SUSITNA HYDROELECTRIC PROJECT

FEDERAL ENERGY REGULATORY COMMISSION PROJECT No. 7114

# COMMENTS

VOLUME 2C TECHNICAL COMMENTS -TERRESTRIAL RESOURCES -SOCIAL SCIENCE

TRR048

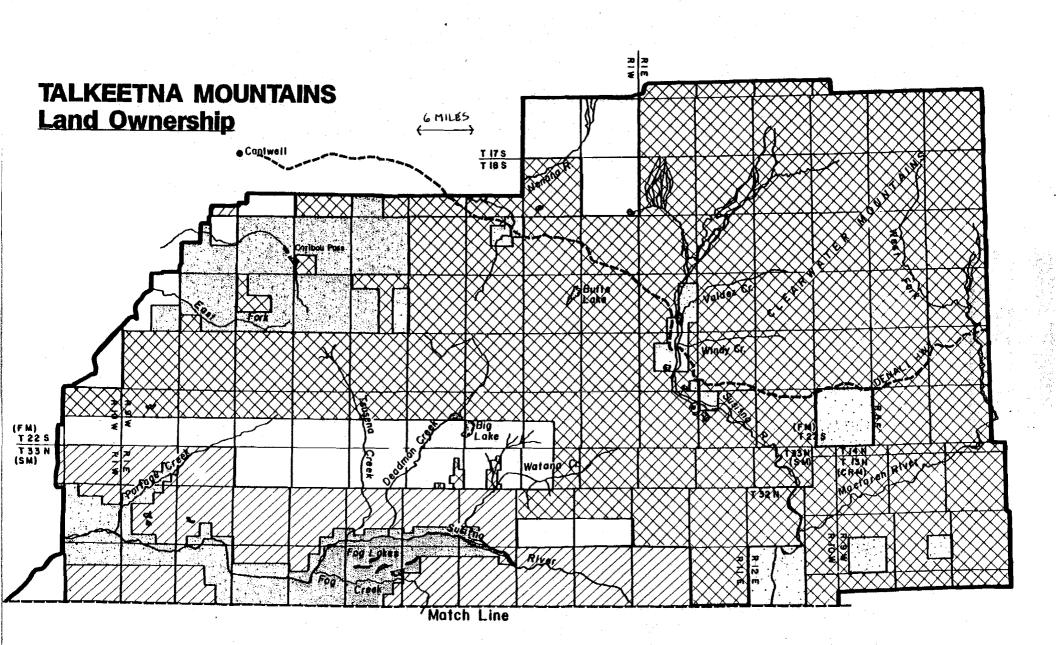
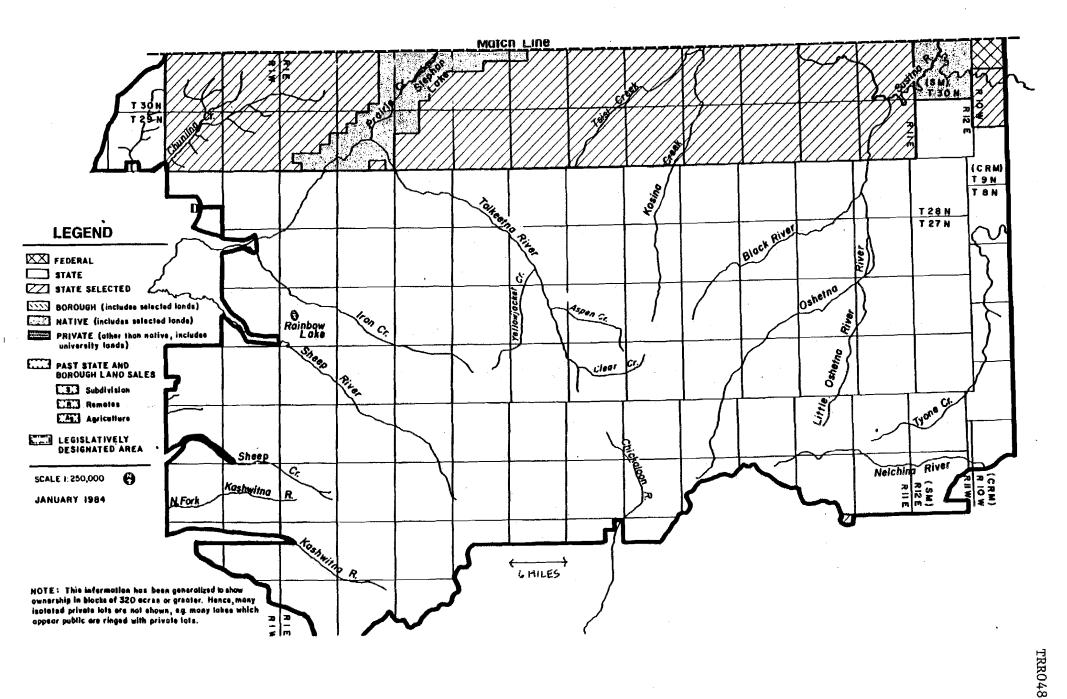
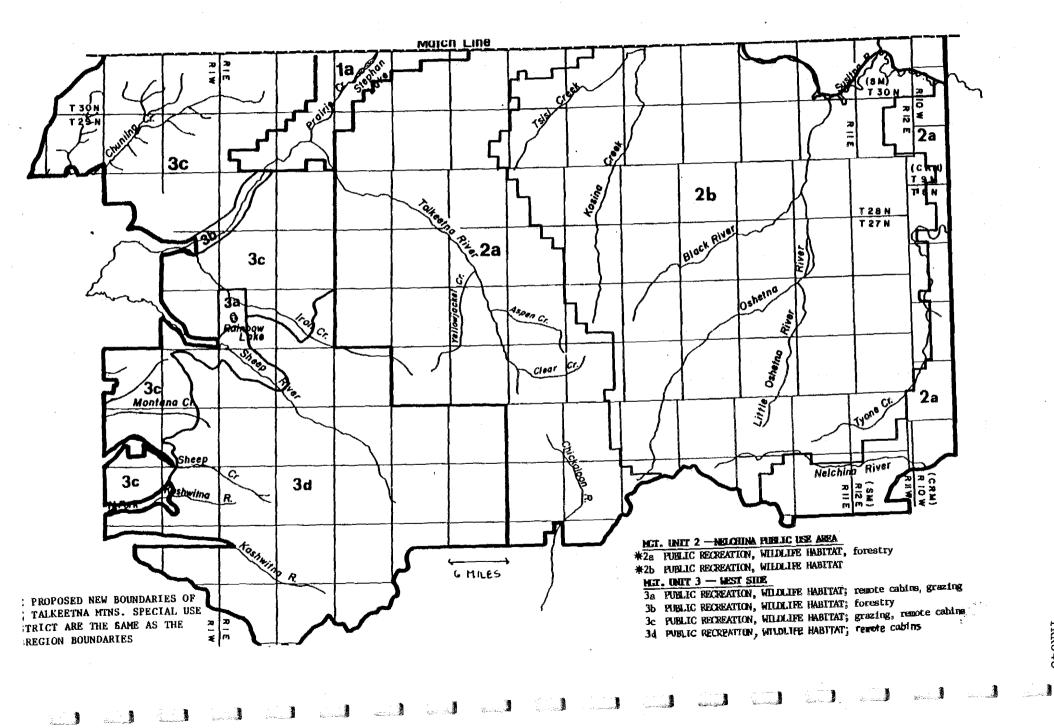
COMMENT IN REFERENCE TO: Candidate mitigation lands for habitat compensation through enhancement.
